Watercare Services Limited

Central Interceptor Main Project Works Section 92 RMA Response Report May 2013

On 8 April 2013, Auckland Council requested further information under Section 92 of the Resource Management Act 1991 (RMA). Watercare's response to that request was provided on 13 May 2013 in the report titled "*Central Interceptor Main Project Works – Section 92 Response Report to Auckland Council*" dated 13 May 2013. As noted in that report, there were some matters still requiring a response. These are addressed in this letter and the attachments.

Figure 1: Manukau Harbour

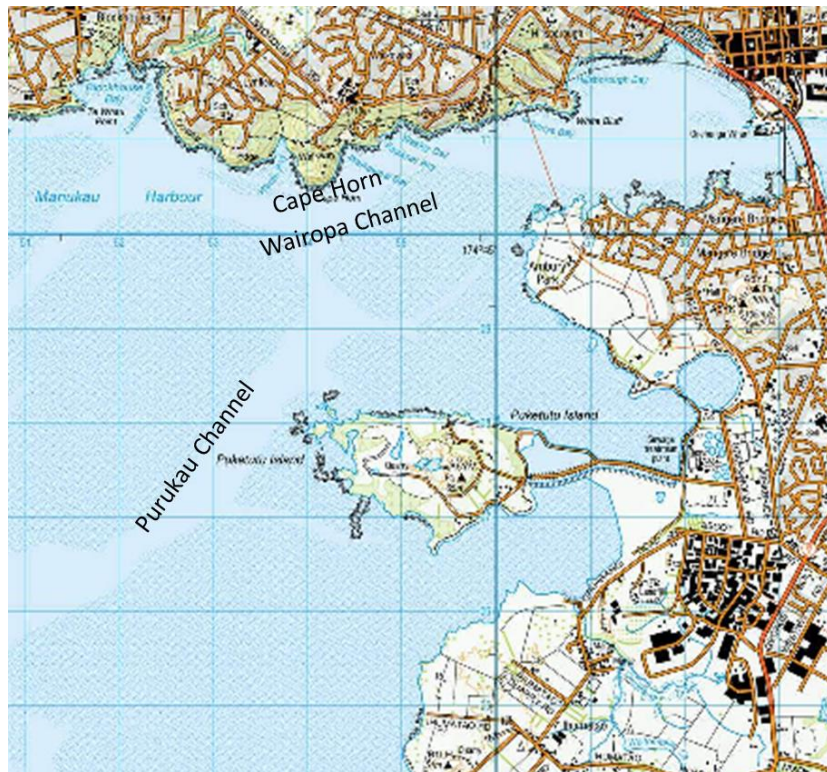
- (b) *Please provide further information in relation to the effects on the environment from the emergency discharge of wastewater to the coastal marine area of the Manukau Harbour in the event the discharge does occur. In particular:*
 - (i) *Please provide a targeted assessment of effects of the potential discharge from the proposed EPR structure with particular regard to with regard to effects on public health, recreational use areas, ecological values and on any areas with identified cultural values. As an example, a risk assessment based on likely consequences of the discharge on the environment and identifying short, medium and any long term risks to any of the identified values can satisfy this requirement.*

Watercare has previously completed studies of discharge dispersion in the Manukau Harbour for discharge from the tidal storage basin under a range of tidal conditions. Based on those previous studies, discharge from the EPR occurring during outgoing tidal conditions would see the discharge disperse in a westerly direction past Puketutu Island and into the main Purukau Channel, from where it would be transported towards the south west. Incoming tidal conditions would then disperse the discharge back up the harbour in the Purukau Channel and the Wairopa Channel towards and onto the Hillsborough coast, impinging on the shoreline from about Cape Horn and the series of bays and beaches to the east (Waikowhai, Faulkner Bay, Granny's Bay, and Hillsborough Bay). These locations are shown in Figure 1 below.

Discharge occurring on the incoming tide would see dispersion restricted to the north of Puketutu Island, and the discharge water being dispersed towards the Hillsborough coast and Mangere inlet, and as the tide rises, against the Ambury shoreline also.

Overall, until dispersed into the Purukau Channel and beyond, the discharge will see only limited dilution, but then tidal mixing will provide rapid dilution.

Roma Road Access Drawing

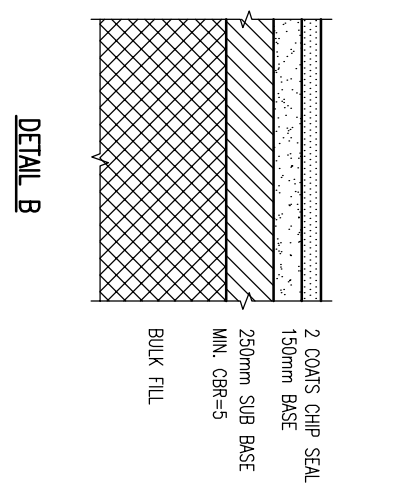
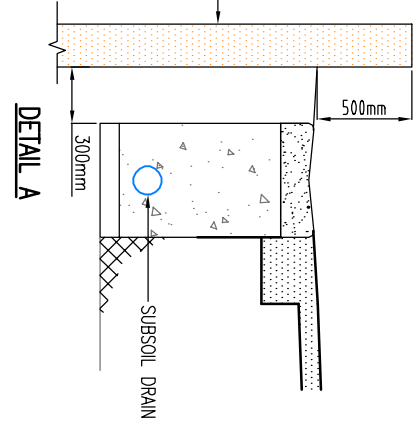
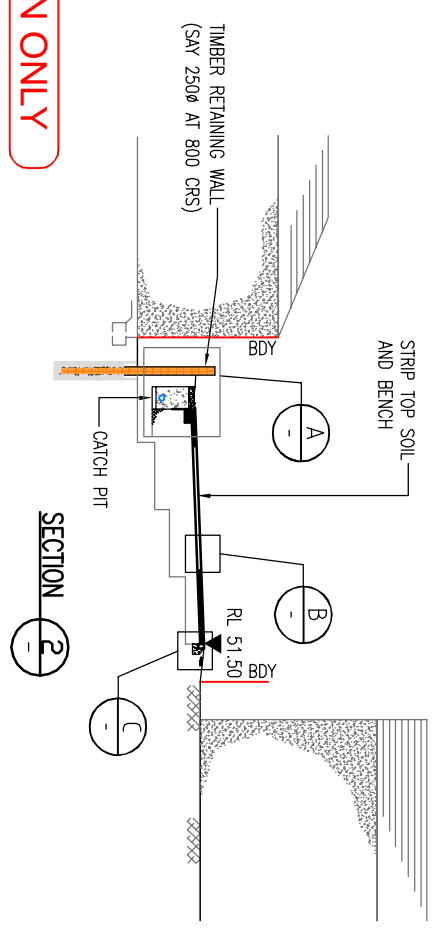
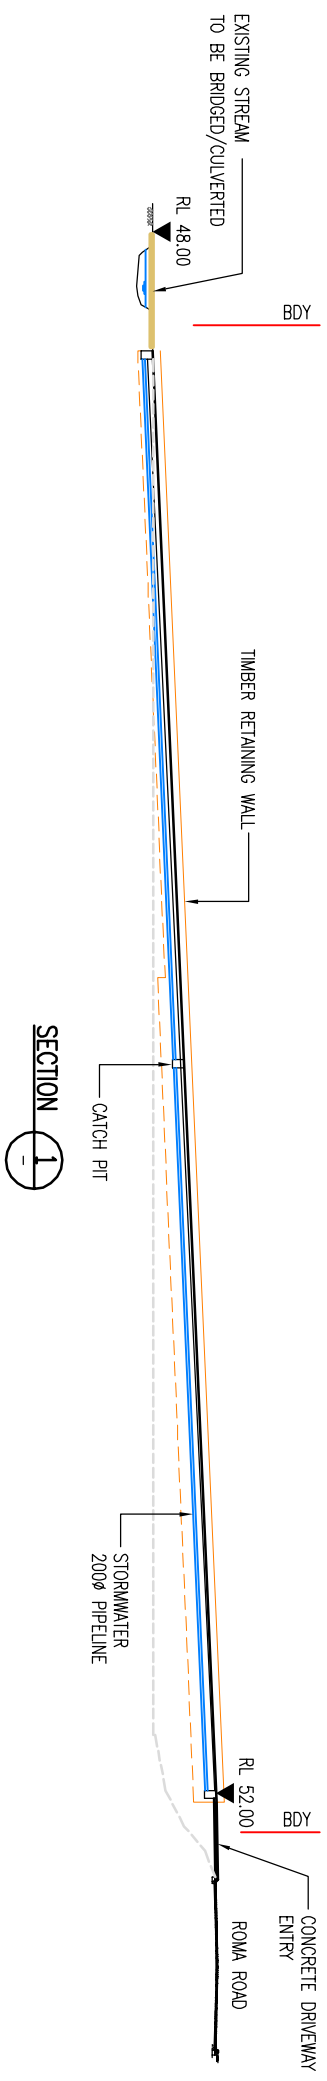
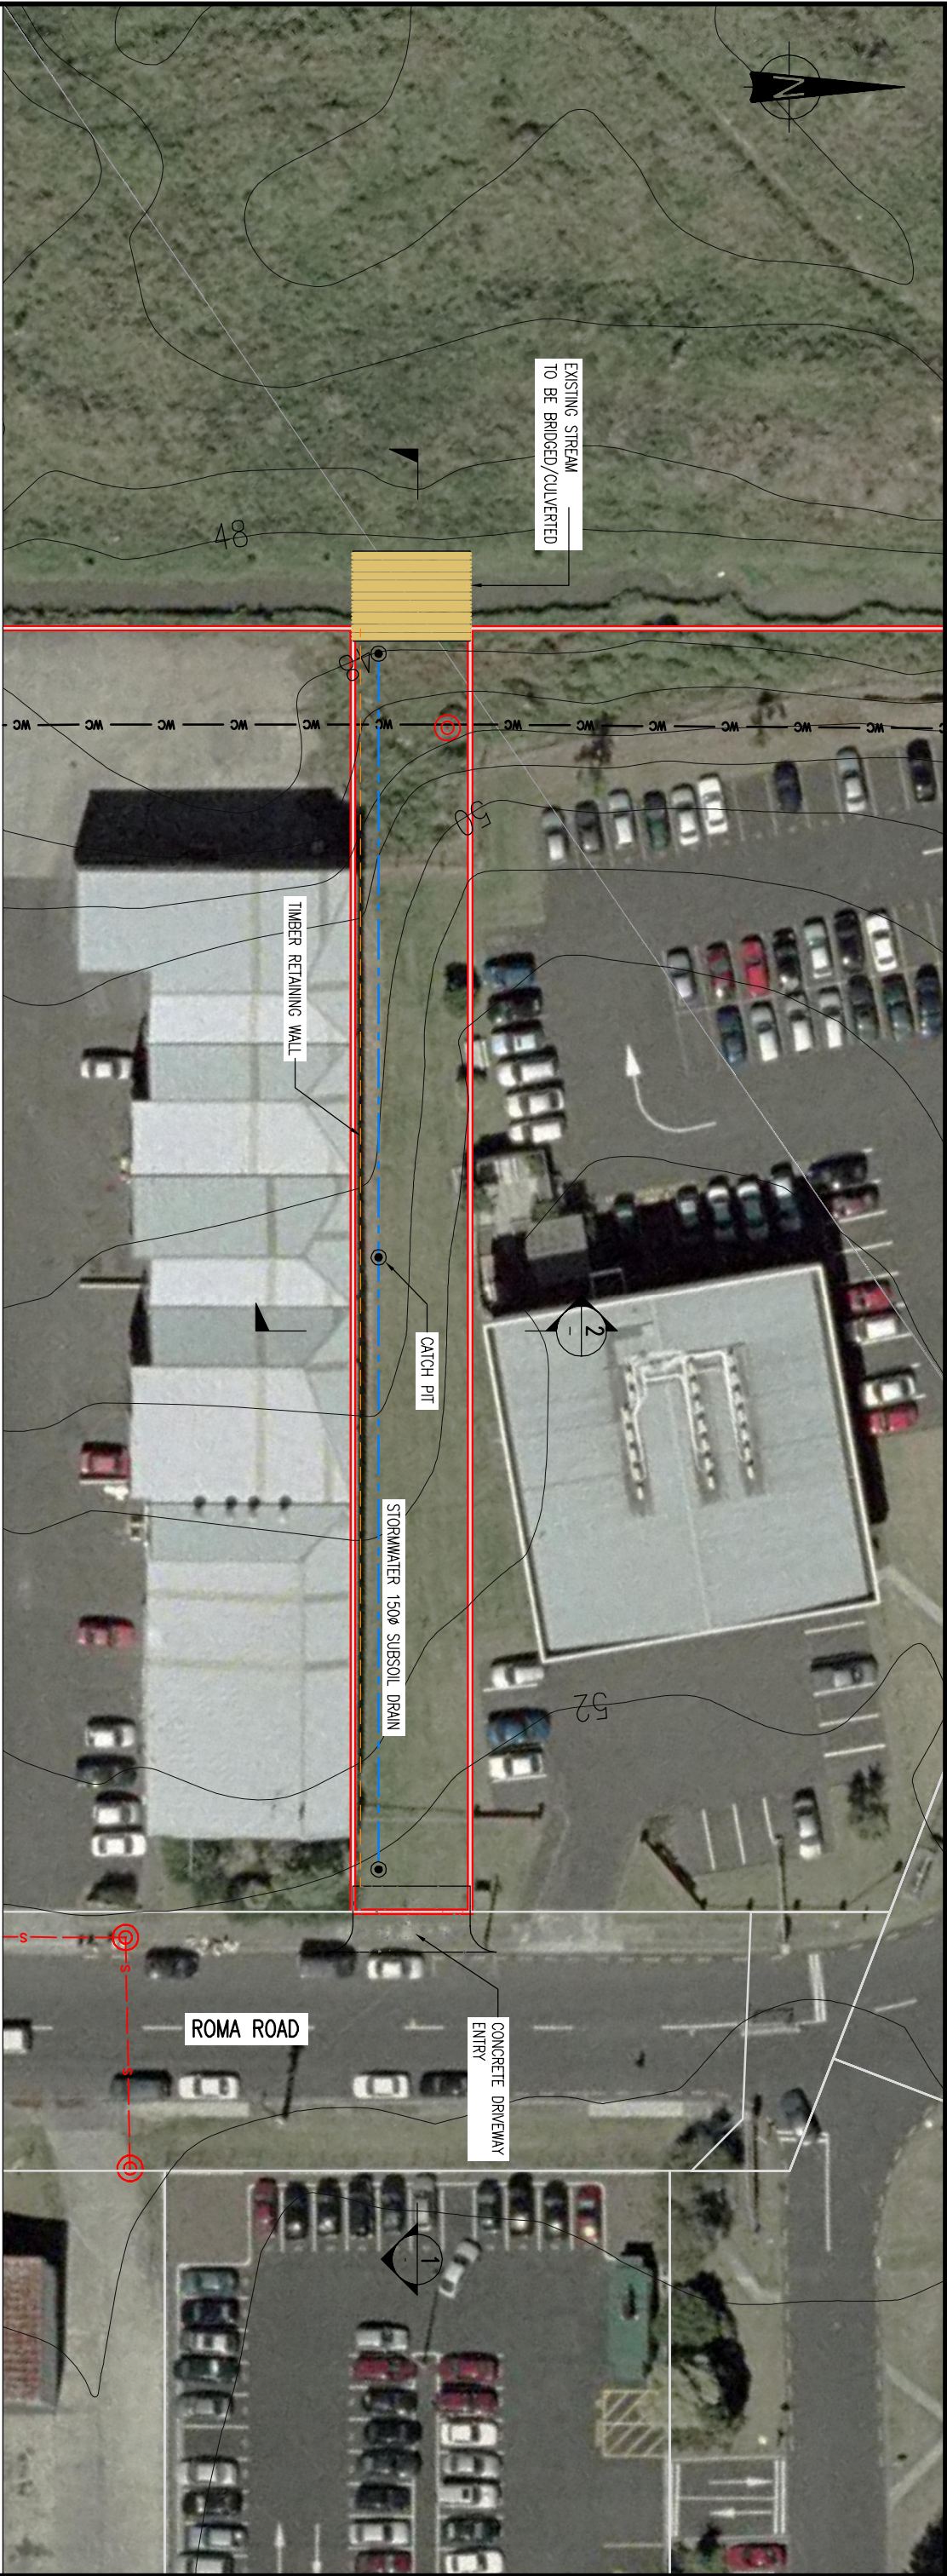
Site access to the May Road site is proposed via Roma Road. The access is currently unformed and physical works will be required to form this access so that it is suitable for use by construction traffic. The details of these physical works will be developed during the detailed design phase and will be provided with the Outline Plan of Works for the site.

DRAWING No.
AEE-MAIN-3.2

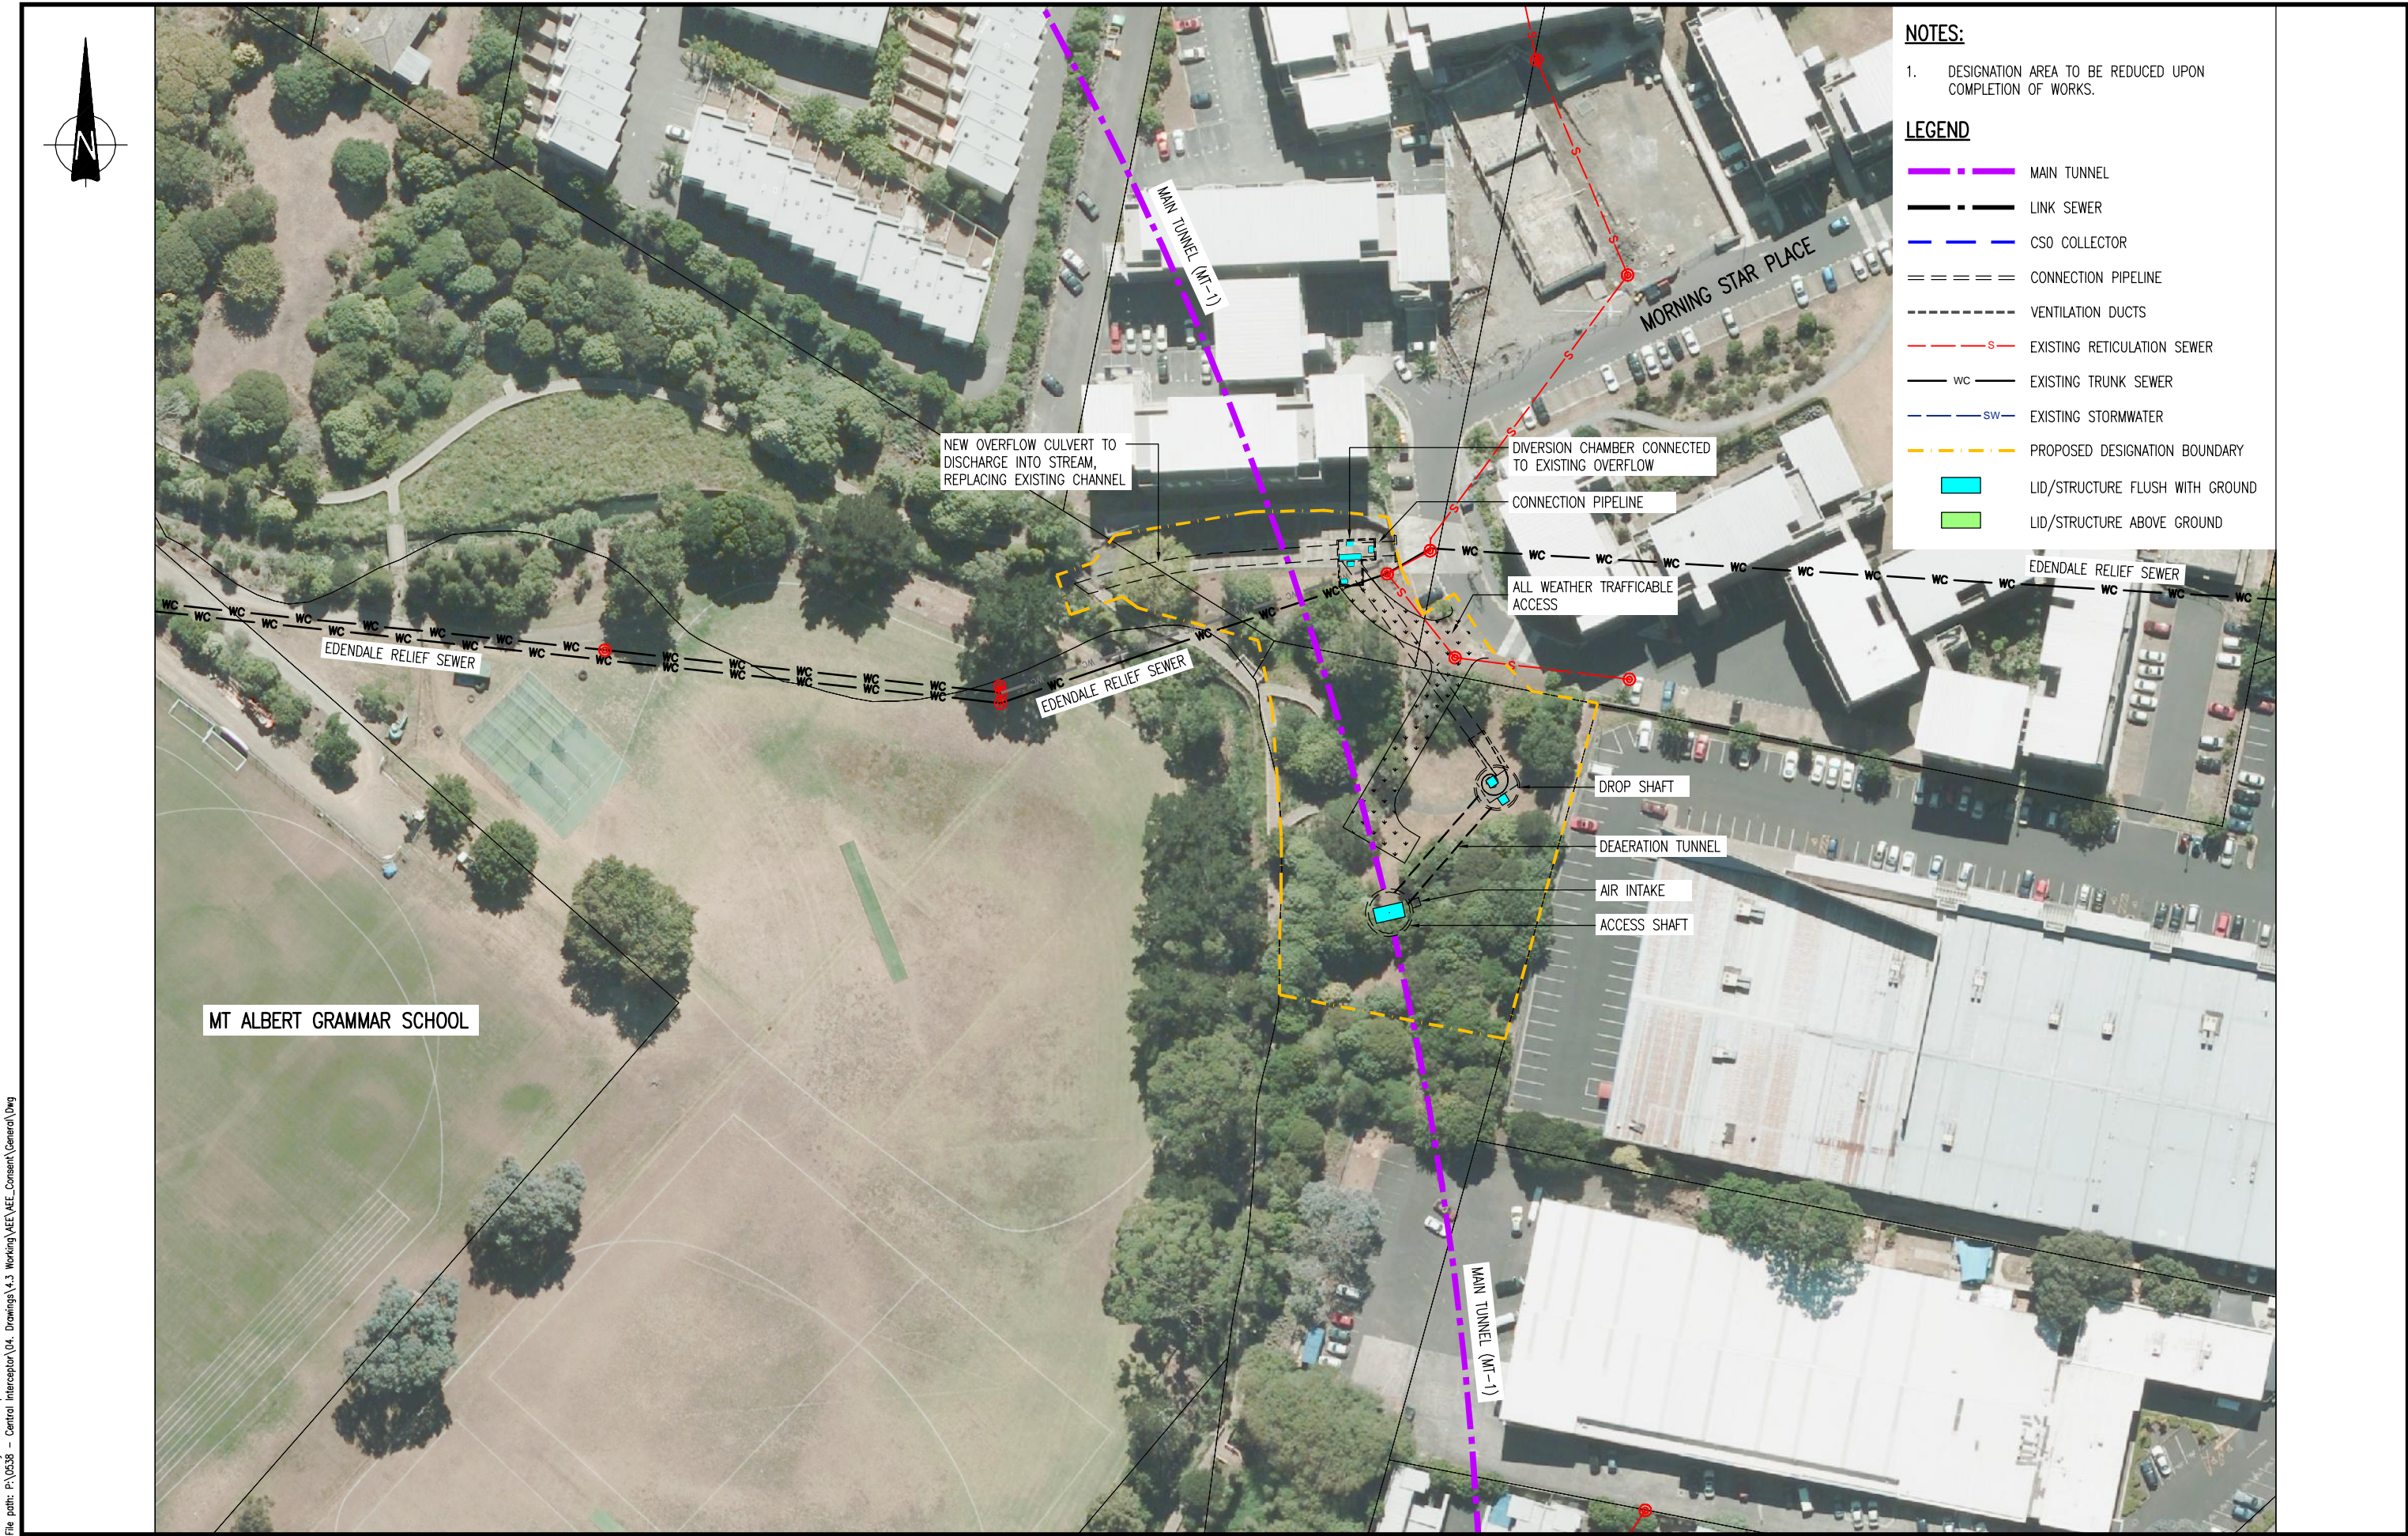
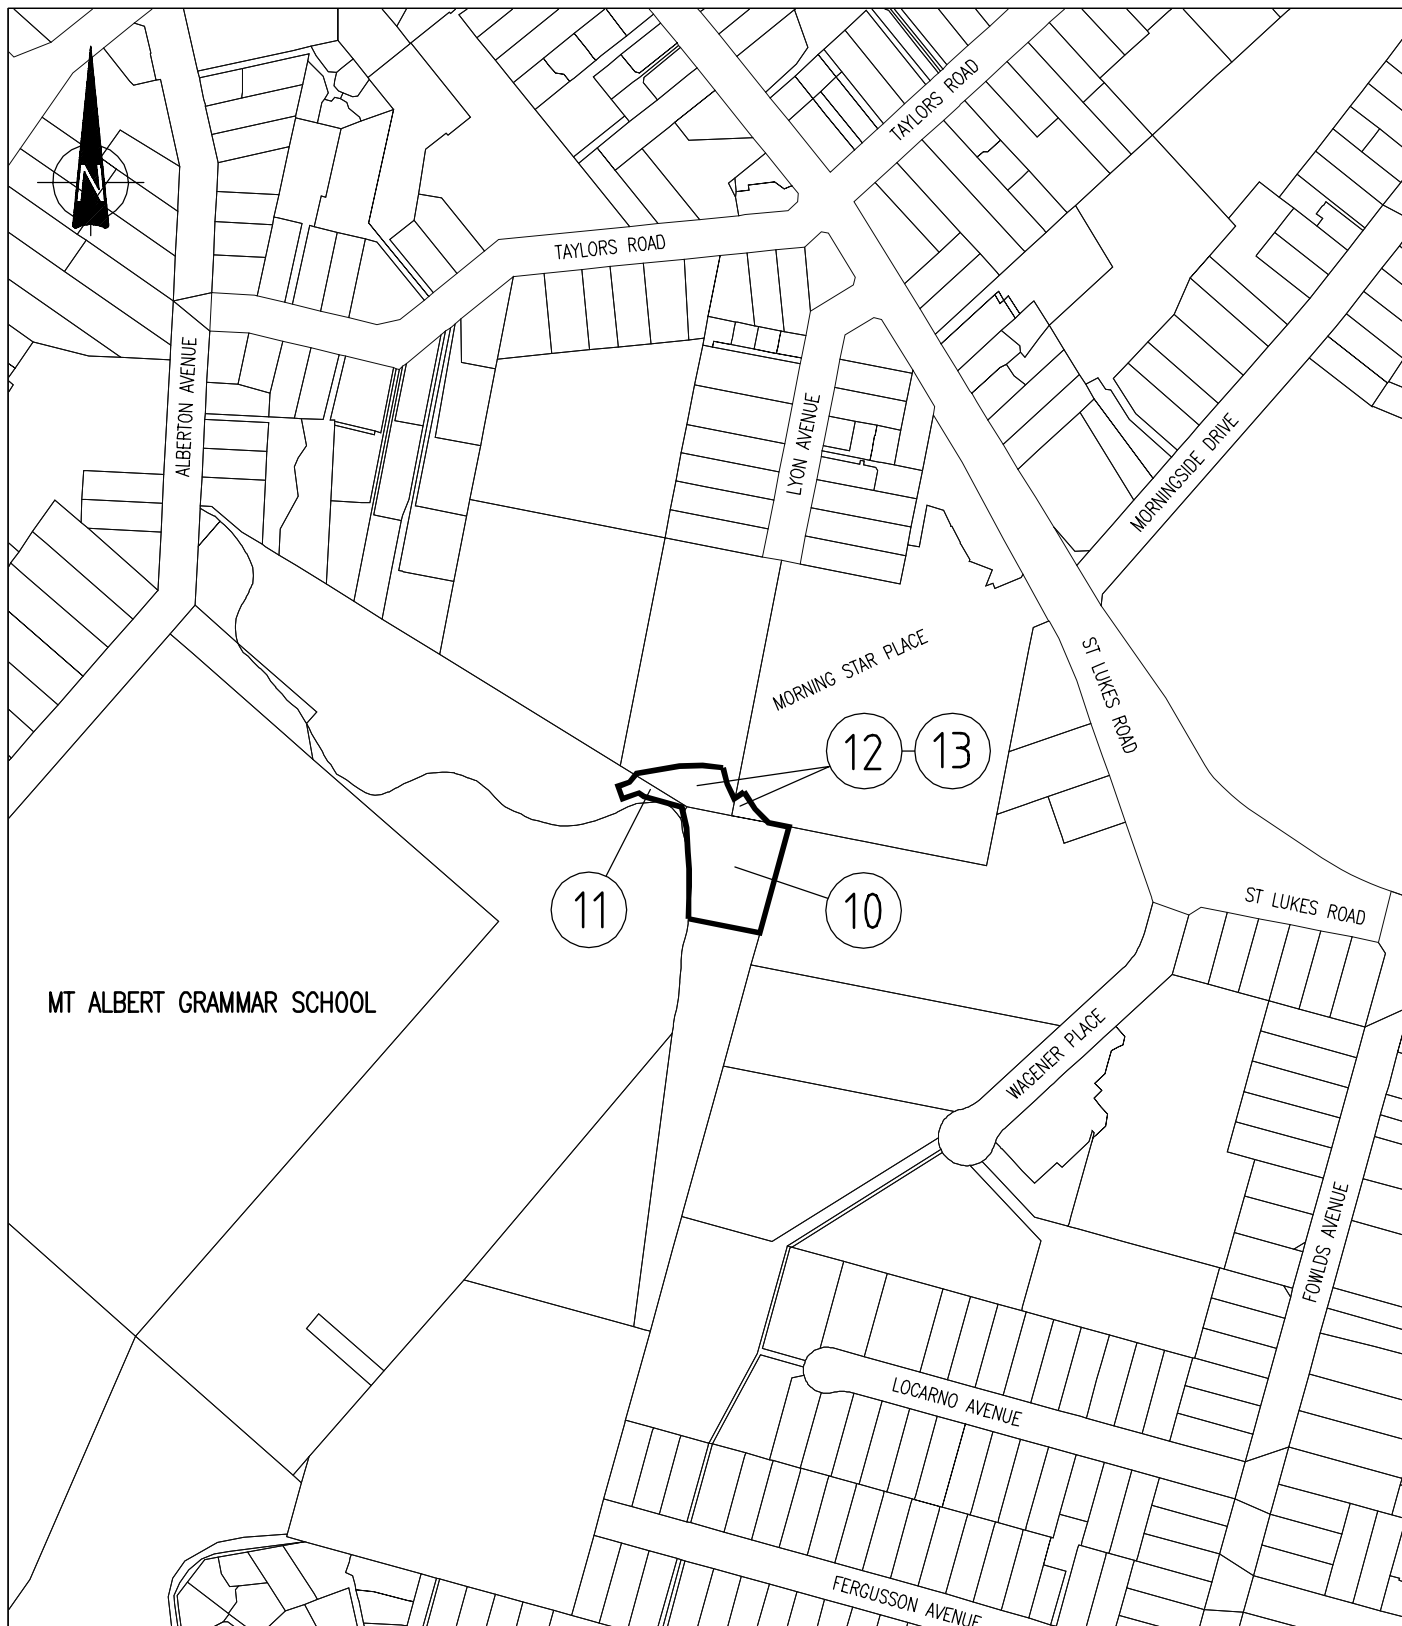
In response to recent consultation with the directly affected landowner at the Lyon Avenue site, we propose to make a minor amendment to our proposed designation boundary. The proposed designation at Lyon Avenue included a number of privately owned car parks on Morning Star Place. A minor adjustment to the boundary of the proposed designation is now proposed so that it no longer includes these car parks. The proposed designation (as amended) and the works to be undertaken are shown on the following updated drawings included in **Attachment 7**:

- AEE-NOR1-3 Issue B. Amended designation plan showing the revised proposed designation.
- AEE-MAIN-3.1 Issue B. Amended permanent works drawing.
- AEE-MAIN-3.2 Issue B. Amended construction works drawing.
